HISTORIC AND DESIGN REVIEW COMMISSION

October 19, 2022

HDRC CASE NO: 2022-506
ADDRESS: 825 E HARLAN AVE
LEGAL DESCRIPTION: NCB 7729 BLK 9 LOT E 171.7 FT OF 11 THRU 14, EXC SE 6.50FT X 10.15FT
ZONING: MF-33, H
CITY COUNCIL DIST.: 3
DISTRICT: Mission Historic District
APPLICANT: Kevin Sekula/SEKULA KEVIN
OWNER: Kevin Sekula/SEKULA KEVIN
TYPE OF WORK: Installation of doors and windows, driveway modifications
APPLICATION RECEIVED: September 19, 2022
60-DAY REVIEW: Not applicable due to City Council Emergency Orders
CASE MANAGER: Jessica Anderson
REQUEST:

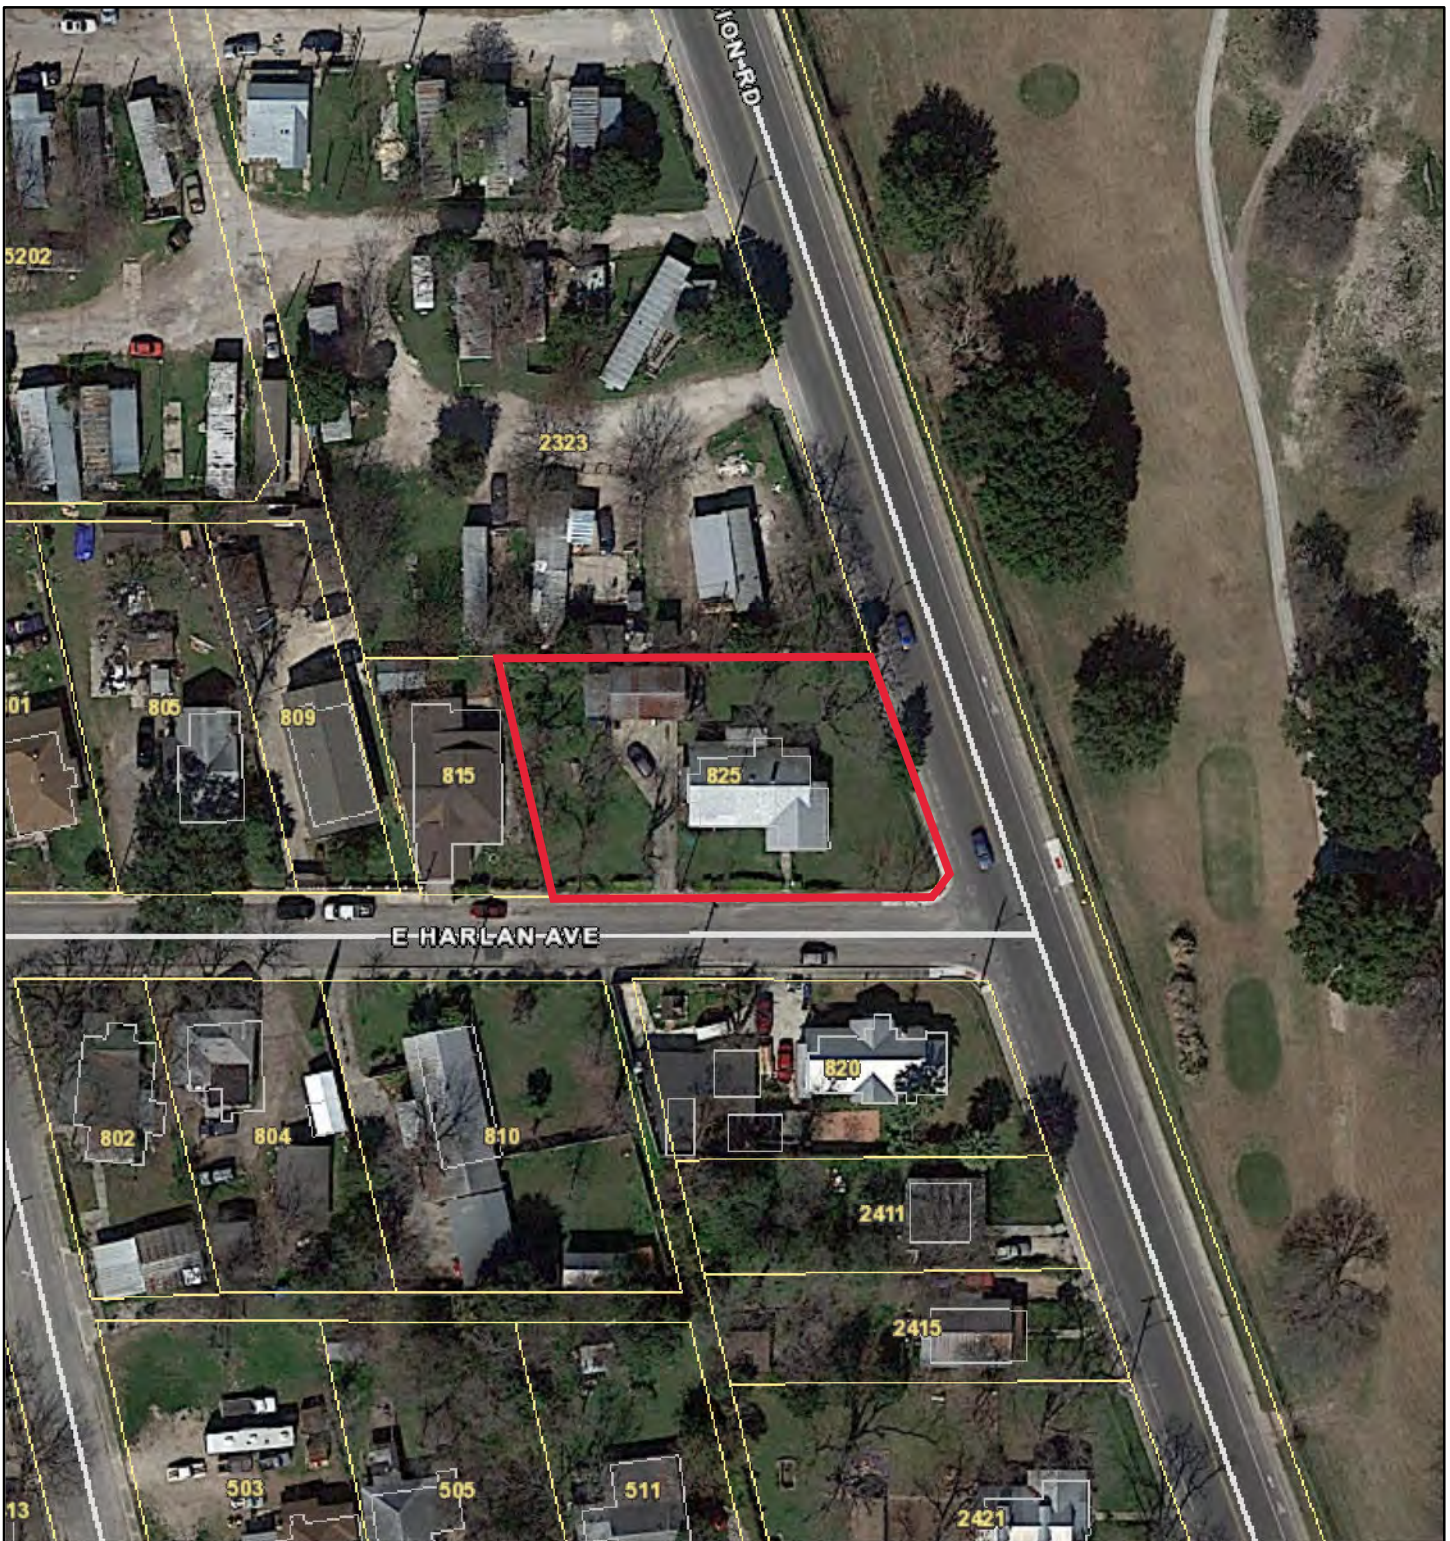
- i. That only the three modern ganged windows on the east elevation be replaced. All existing wood windows should be retained and repaired.
- ii. That the applicant propose a window product to replace the three ganged windows on the east elevation that conforms to Historic Design Guidelines and Standard Specifications for Wood Window Replacement, namely a wood or aluminum-clad wood window product.

- i. That the east and south doors be retained.
- ii. That the applicant propose replacement doors that conform to Historic Design Guidelines, namely wood and of a style appropriate for the house.

EXISTING EXT. DOOR & WINDOW LOCATIONS

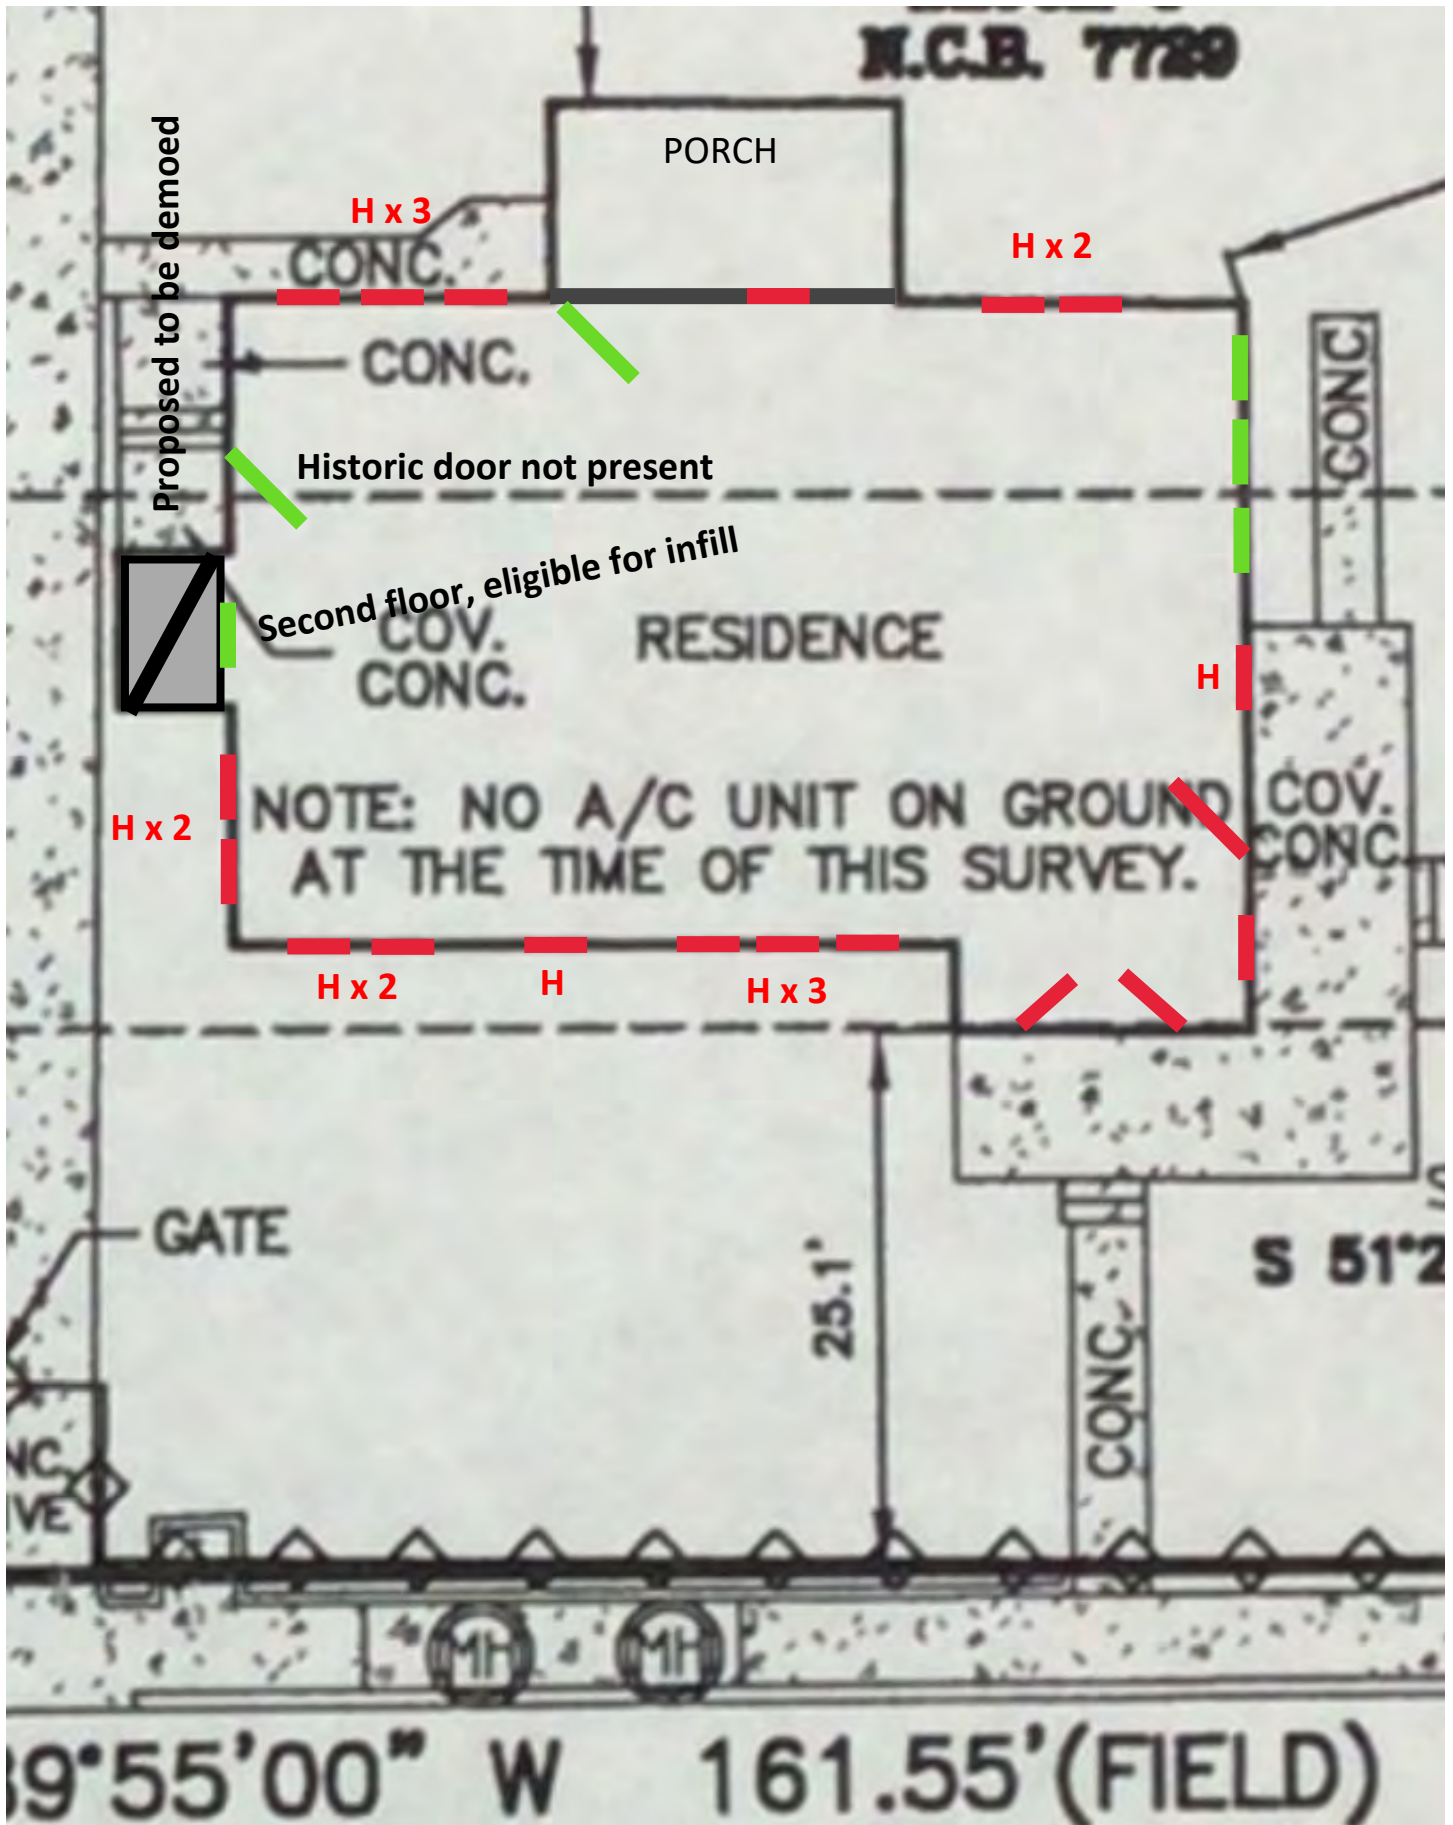
- Historic, to be retained
- Non-historic, eligible for replacement
